## SHOP DRAWING REVIEW

Job Number: BF 013-2(13)
Reviewed By: E.F. LAWES
Date: 02-12-2016

Project: WESTON BF 013-2(13)
WESTON VT 05161

Drawing: CLOSURE POURS REINFORCEMENT

ABUTMENT CLOSURE POUR SECTION

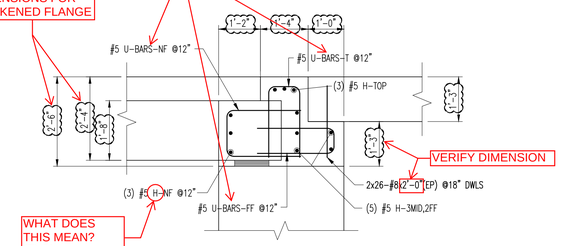
PLEASE INCLUDE BAR MARKS SHOWN IN ELEVATION AND TOP VIEW IN SECTION VIEW AS WELL.

VERIFY DIMENSIONS FOR THICKENED FLANGE

VERIFY DIMENSION

WHAT DOES THIS MEAN? (TYP)

CLARIFY? (TYP)

ALSO INCLUDE A DECK CLOSURE POUR SECTION AT THE THICKENED FLANGE.
